WATTS BAR NUCLEAR PLANT (WBN) UNIT 1 - RESPONSES TO REQUEST FOR  
ADDITIONAL INFORMATION (RAI) REGARDING TRITIUM PRODUCTION -  
INTERFACE ITEM NUMBER 3 - COMPLIANCE WITH DNB CRITERION -  
CLARIFICATION TO PREVIOUS RAI RESPONSE DATED SEPTEMBER 21, 2001  
TAC NO. MB1884

ENCLOSURE  
TENNESSEE VALLEY AUTHORITY  
WATTS NUCLEAR PLANT (WBN)  
UNIT 1  
DOCKET NO. 390  
RESPONSE TO NRC'S REQUEST FOR ADDITIONAL INFORMATION

Figure 3.1  
Results of Analysis of Condition I Power Shapes

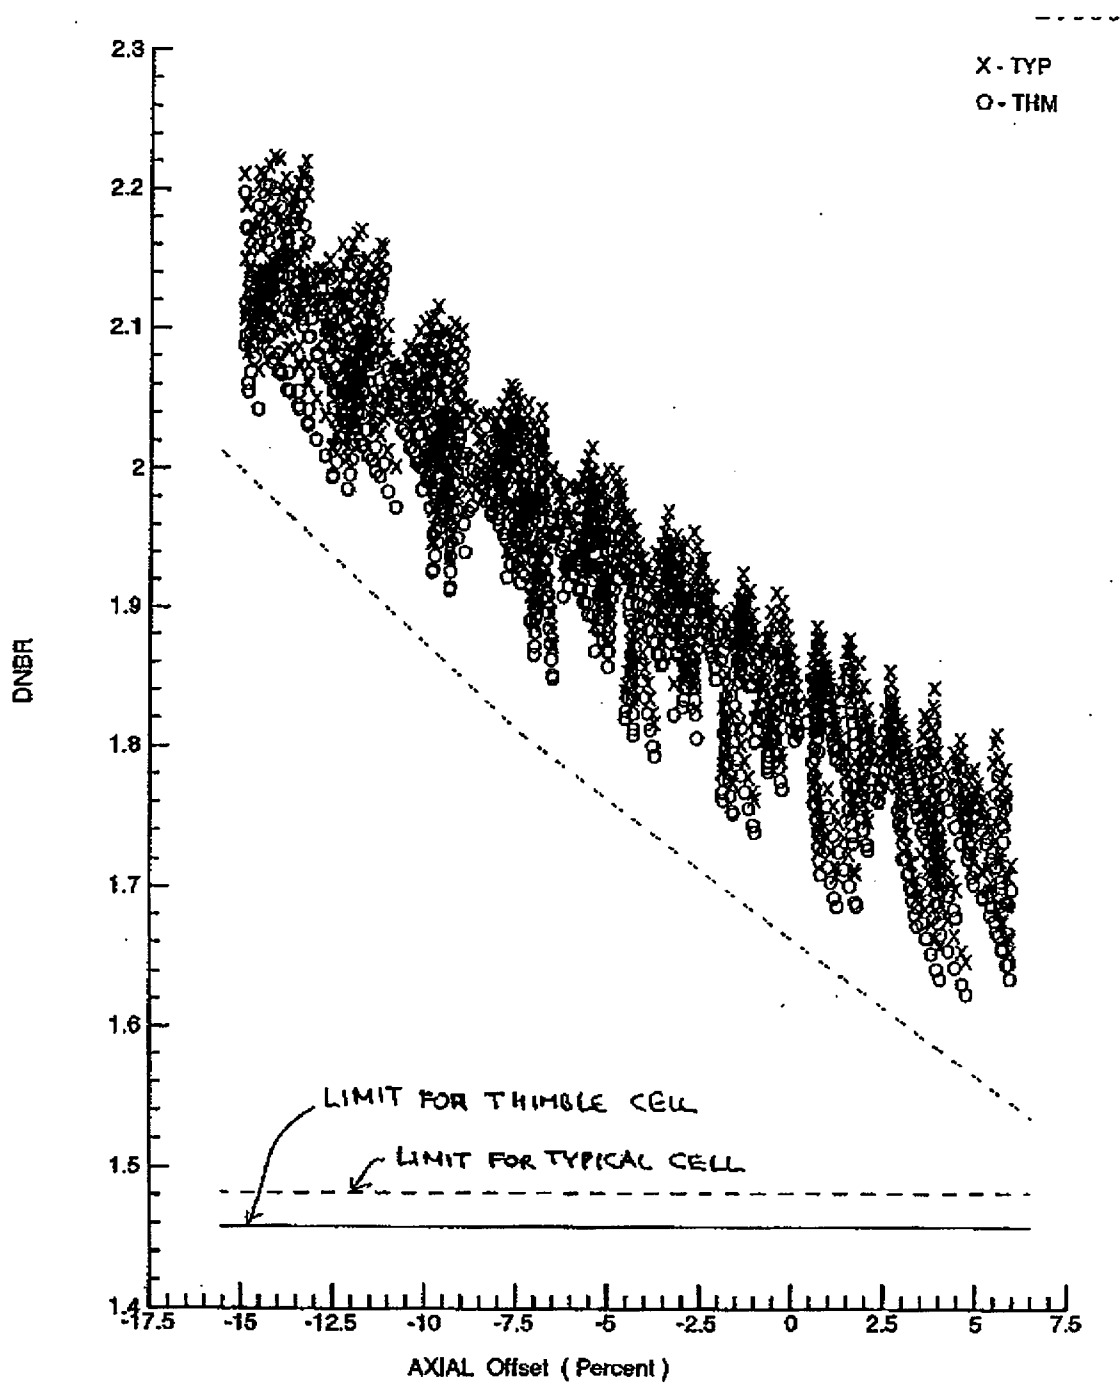
For the comparisons stated in the first paragraph of Section 2.4.4.5, on page 2-28, please provide the results of the comparisons (i.e., plots, sketches, etc.)

Figure 3.1 shows the results of the analysis of the Condition I axial power shapes for an equilibrium core of TPBARs. The figure plots DNBR versus Axial Offset, where Axial Offset is defined as the power generated in the top half of the core minus the power generated in the bottom half of the core divided by the total power generated (times 100 to give the standard unit of percent). Each circle or x corresponds to a power shape for a thimble or typical cell, respectively. The dotted line which bounds the data points is taken from the reference power shape analysis for a non-tritium core. This line is used to verify future cycle specific power shapes. The horizontal limit lines show on the figure for the thimble and typical cell correspond to a DNB limiting axial power shape used to analyze such transients as Loss of Flow.

Figure 3.2A  
Results of Analysis of Condition II Power Shapes  
Typical Cell

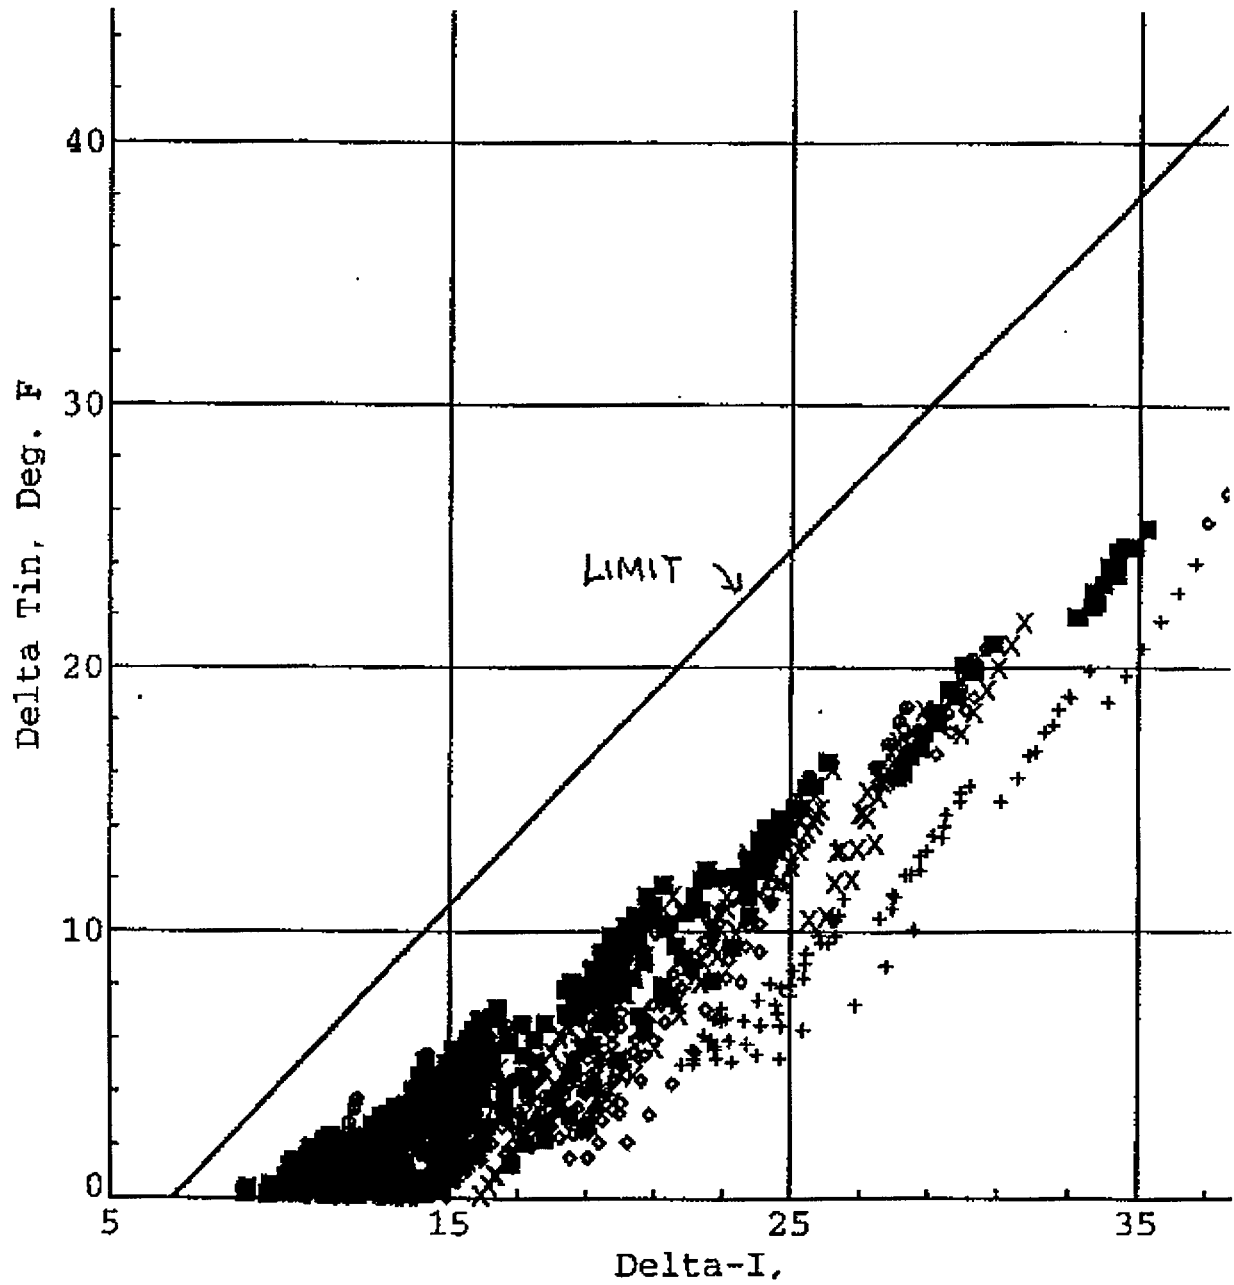
On pages E-7 and E-8, revise the titles for Figures 3.2A and 3.2B as per attached pages (changes denoted by revision bars):

Figures 3.2A/B show the results of the analysis of the Condition II axial power shapes for an equilibrium core of TPBARs for typical and thimble cells, respectively. The figures plot  $\Delta T_{in}$  versus  $\Delta I$ , where  $\Delta I$  is defined as percent of core rated power generated in the top half of the core minus percent of core rated power generated in the bottom half of the core. Each point corresponds to a power shape.

These figures show that the limit lines bound the accident power shapes associated with the tritium cores. The limit lines were established for non-tritium cores and are applicable to the tritium cores. These lines were used as input to establish the  $f(\Delta I)$  function setpoints in the Overtemperature  $\Delta T$  equation.
